Response to S. 131 from
Barna Wind Energy (BWE) Ltd

Re: Barnadivane Wind Farm, Co. Cork, (An Bord Pleanála Planning Ref. PL04.248153, Cork County Council Planning Ref. 14/6760 – Response to Third Party Submissions made to An Board Pleanála

**BARNADIVANE WIND FARM, CO. CORK, (AN BORD
PLEANALA PLÁNNING REF. PL04.248153, CORĀ
COUNTY COUNCIL PLANNING REF. 14/6760) –
RESPONSE TO THIRD PARTY SUBMISSIONS MADE TO
AN BORD PLEANÁLA**

Figure 3-1: Scenic Routes in Vicinity of the Development.

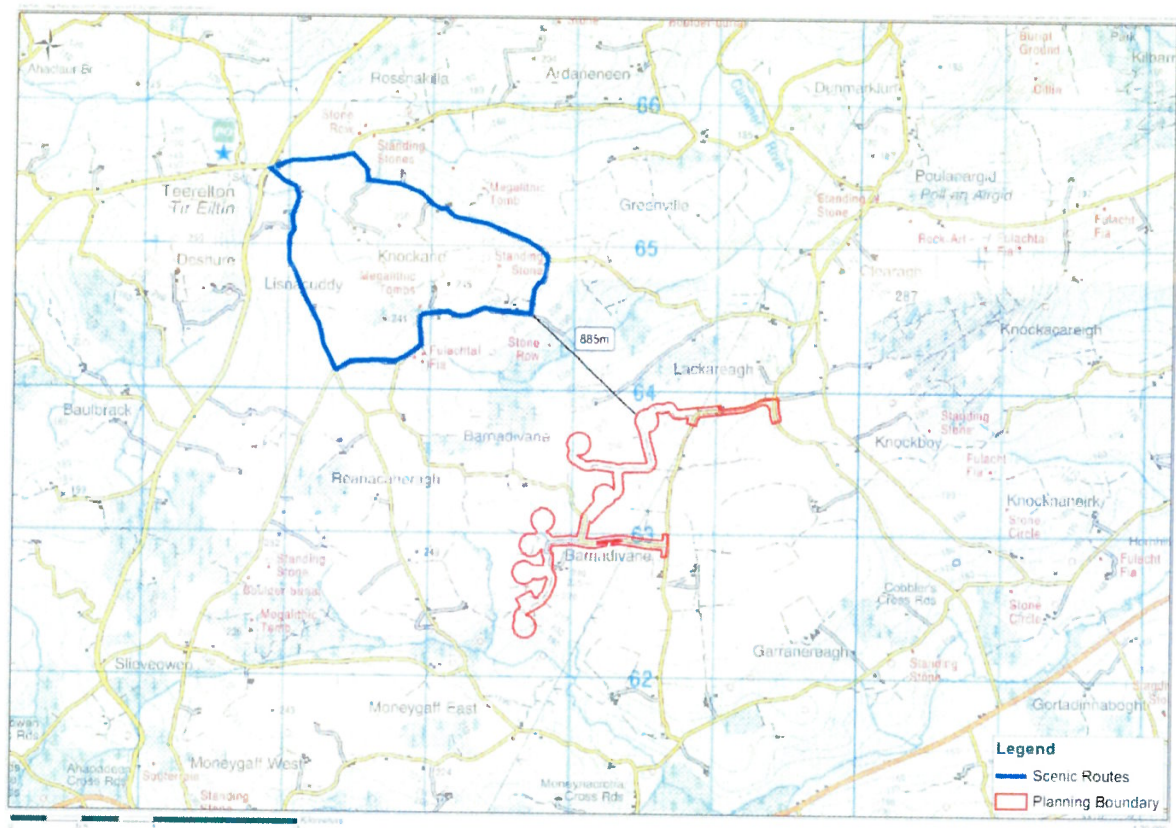
There is a signposted walk, which runs along part of a recognized scenic route along the south-western boundary of the site on the road which goes between T3 and T4 to the east. There are 2 local walking groups using these walks on a regular basis.

No submissions were received from Kilmurray Harriers or other hunting groups in relation to this site being of important use for local hunting activities. Similarly, no submissions were received from local walking groups in relation to their use of the site. Figure 3.1 below indicates that the planning boundary is 885m from the closest scenic route. No recreational trails are in evidence in the vicinity of the site on the Irish Sports Council website www.irishtrails.ie. While there are tracks adjacent to the site (grey pecked lines), none of these are marked as waymarked walks in the Ordnance Survey Discovery Series mapping (red pecked lines). It is also important to note the road along the south western boundary is a public road which will not be negatively impacted from the wind farm. Furthermore, wind farms are recognized as sites which can enhance and encourage recreational amenity. In this regard, we note the success of the recreational trail at Mount Lucas Wind Farm Co. Offaly and also the trail being developed in Slieve Bawn Wind Farm in Co. Roscommon. www.sliabhawnwindfarm.ie.

APPENDIX 1 – SITE PLAN: H38, H54 & H55 LOCATION IDENTIFICATION

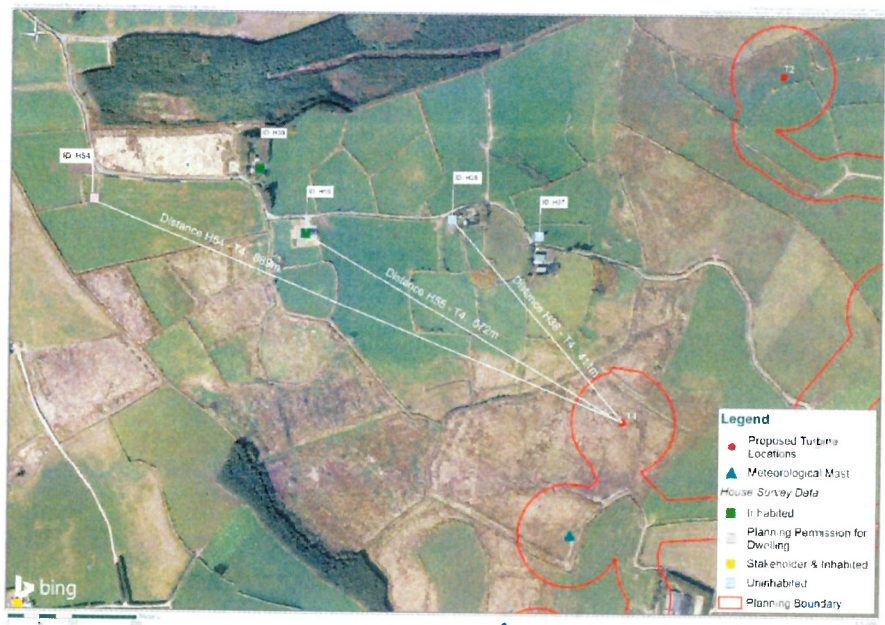
While Mr Manning's written submission identifies his properties as H54 and H55, it should be noted that he has identified H55 and H38 in the first figure of his submission as his investment property and his dwelling respectively. However, H38 is considered to be a derelict property for the purpose of the EIS and therefore, following the wind farm planning guidance, has not been considered for noise assessment.

the nearest proposed wind turbine. It should be noted that Mr Manning has identified H38 within the first figure of his submission as the property at which he resides. However, H38 is considered to be a derelict property for the purpose of the EIS and therefore, following the wind farm planning guidance, has not been considered for noise assessment. It is our understanding that Mr. Manning resides in H55. Appendix 1 details the locations of H38 and H55 for ease of reference.

ELEVATION SECTION A-A (FUTURE RING STATION ADDED)

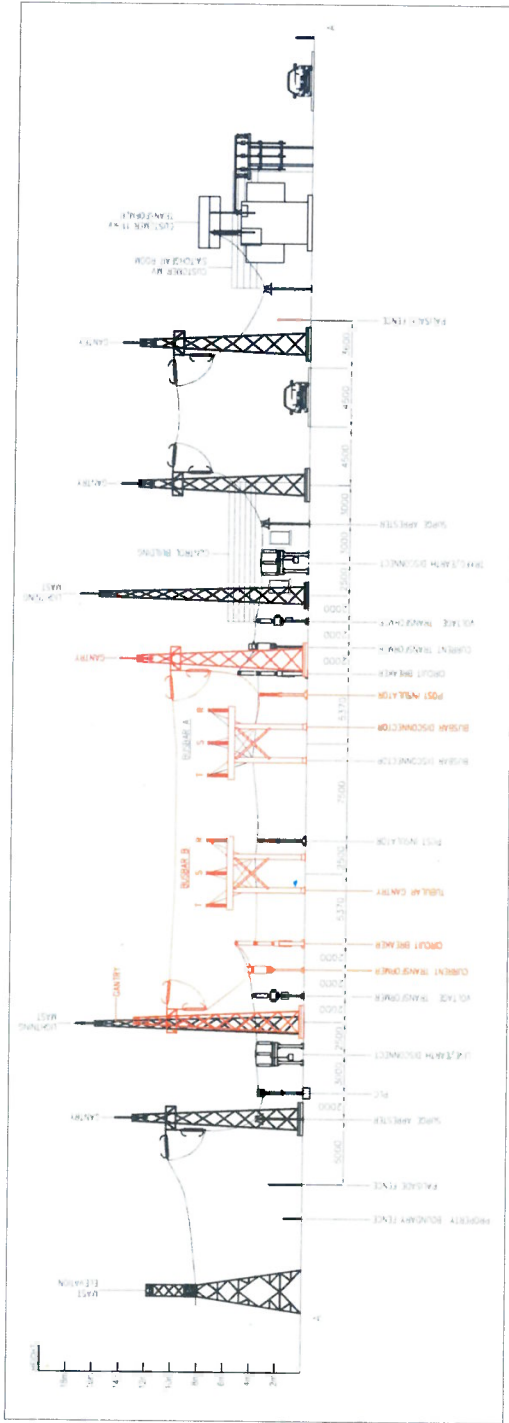
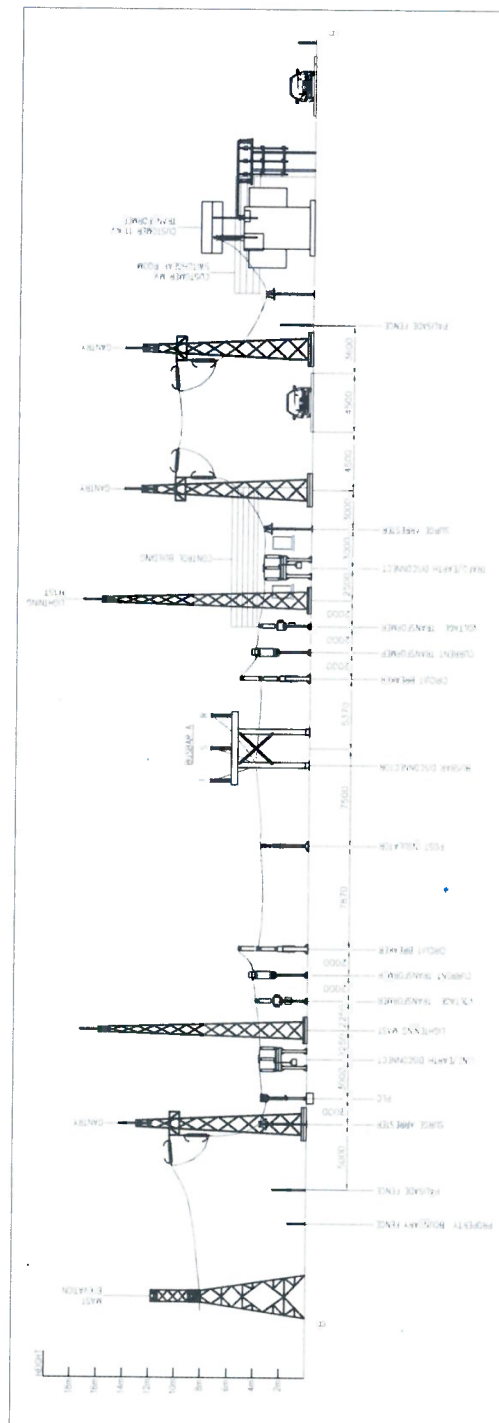
We believe that the unresolved issues with regard to the alleged revised Eirgrid substation layout, size, capacity and location. We have asked for direct confirmation or evidence to be provided from Eirgrid for the alleged need for a 60mW substation but this has failed to materialize. We also want to see evidence for and the nature of a grid connection at Barnadivane and evidence for and the nature of a grid connection at the newly proposed Carrigariork to Dunmanway.

'As can be seen in the EirGrid drawings the requirements now include that the substation be suitable in its electrical plant layout and overall footprint size to allow for potential future expansion (this is identified in red in the EirGrid drawings). We also note the differences in building sizes and electrical plant configuration. EirGrid will operate the majority of the substation when the construction is completed; however, they will not take control of a substation that does not fulfil their current or at the least a very recent specification'.

The planning application before the Board is as presented. For the purpose of responding to the third party, the link below is to a PDF on the Eirgrid website which confirms that Barra are contracted to Eirgrid to provide 60MW of electricity. <http://www.eirgridgroup.com/site-files/library/EirGrid/Contracted-TSO-Wind-Farms-1-May-2017.pdf>
